Responses to comments submitted during the balloting of the Monitor and Assess short-term Transmission Reliability, Operate within Interconnection Reliability Operating Limits standard

The Operate within Limits Standard Drafting Team thanks all those who submitted comments with their ballots on the recent posting of this standard. After careful review and consideration of all comments received, the drafting team has modified the standard and is re-posting the standard for another 45-day comment period.

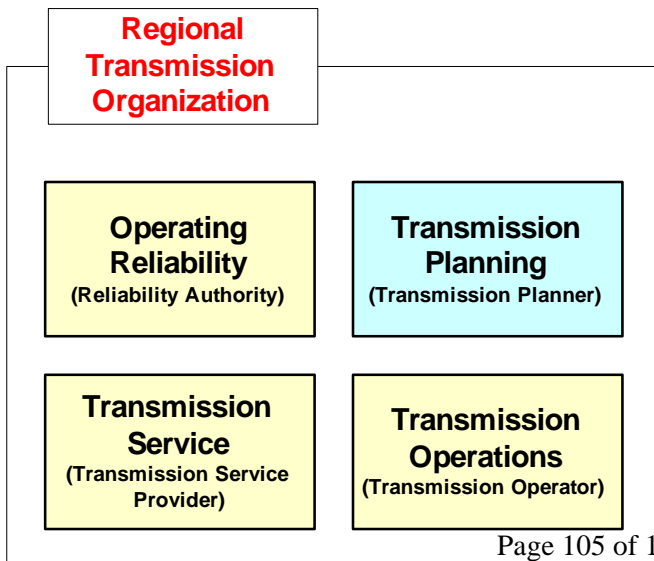
perform this function, especially in light of RTO roles and the proposed NERC functional model definitions.

Each balloter is asked to vote on what is in the standard presented to them - nothing more or less. To the extent that the standard depends on another as yet not fully defined standard requires the balloter to be involved in the process and comment on what should and what should not be in the standard. NERC Director-Standards is responsible for ensuring that ad hoc expectations between standards are effected.

The Functional Model contains a description of the responsibilities of the RA. Some entities are having difficulty trying to determine if they want to assume responsibility of the RA or the TOP. Each entity must make these decisions for itself. The Functional Model was approved by the NERC Board of Trustees in June, 2001. There are revisions to the Functional Model that are under consideration, but these revisions primary address 'format' and not 'content' issues. The Standing Committees approved Version 2 of the Functional Model in November, 2003. The Functional Model may continue to undergo changes to conform to changes in the industry. While this is not ideal, there is nothing the Standards Development Team can do about this reality. Waiting until the Functional Model is 'finished' could mean that we may never have a set of reliability standards that is clear enough to support the industry's needs. The NERC Board of Trustees has asked the Drafting Teams to move ahead with the development of standards, and that is what we are trying to do.

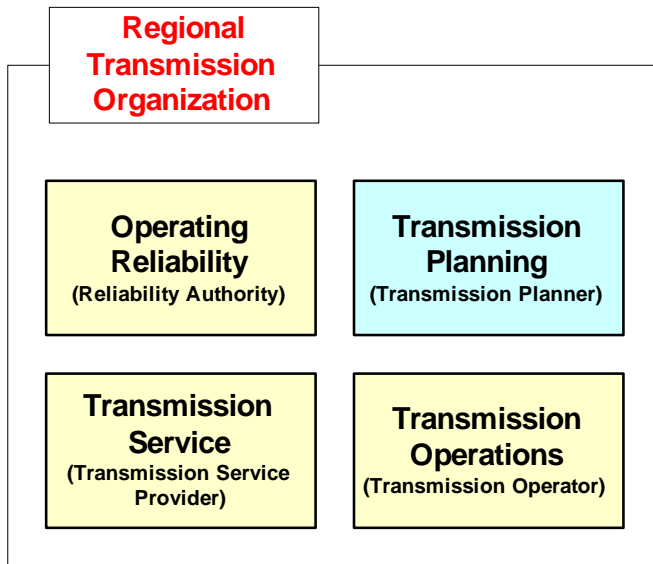
Discussion has generated concern in regards to a lack of clarity on exactly who the "Reliability Authority" will be that performs this function, especially in light of ISO/RTO roles and the proposed NERC functional model definitions.

Each ballot is asked to vote on what is in the standard presented to them - nothing more or less. To the extent that the standard depends on another as yet not fully defined standard requires the ballot to be involved in the process and comment on what should and what should not be in the standard. NERC Director-Standards is responsible for ensuring that ad hoc expectations between standards are

The Functional Model contains a description of the responsibilities of the RA. Some entities are having difficulty trying to determine if they want to assume responsibility of the RA or the TOP. Each entity must make these decisions for itself. In some cases, such as in the case of an RTO, one entity may perform several functions. This is a diagram from the Functional Model Technical Document. It shows how one RTO may perform several of the functions in the Functional Model. This is not a 'prescription' for all RTOs - each RTO must decide what functions it wants to perform.
